Final BPSOU Subdrain Pump Station Remedial Design (RD) Work Plan

RE: Final BPSOU Subdrain Pump Station Remedial Design (RD) Work Plan

**Response to Agency Comments for the
Draft Final BPSOU Subdrain Pump Station Remedial Design (RD) Work Plan
Prepared for Atlantic Richfield Company
By Pioneer Technical Services, Inc.
Dated: September 6, 2022**

Figure 2. National Wetlands Inventory Map

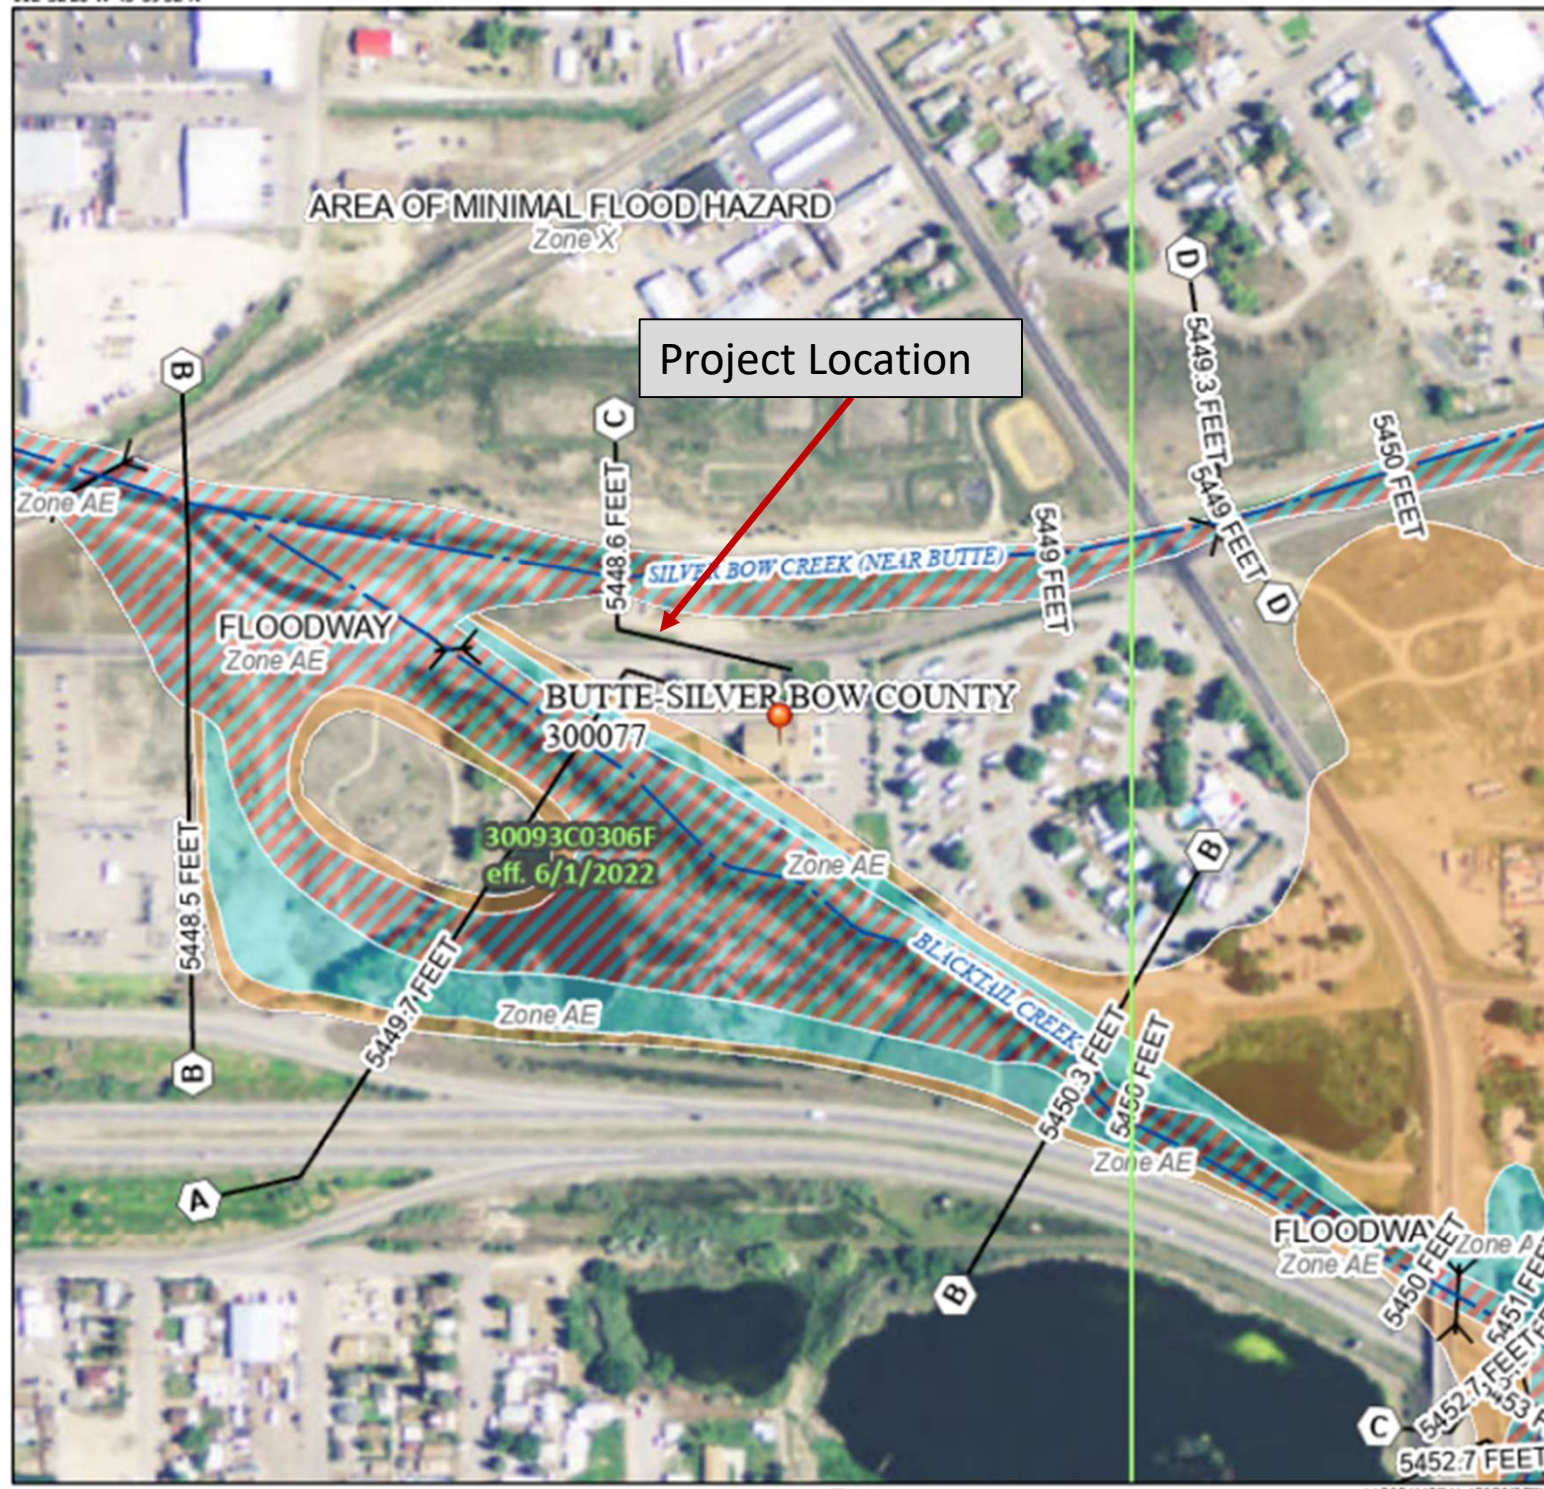
- *Please consider adding a National Wetlands Inventory Figure.*
- *Please consider adding a FEMA Flood Insurance Rate Map panel figure (FIRMette)*

These figures have been added to the RDWP figure set.
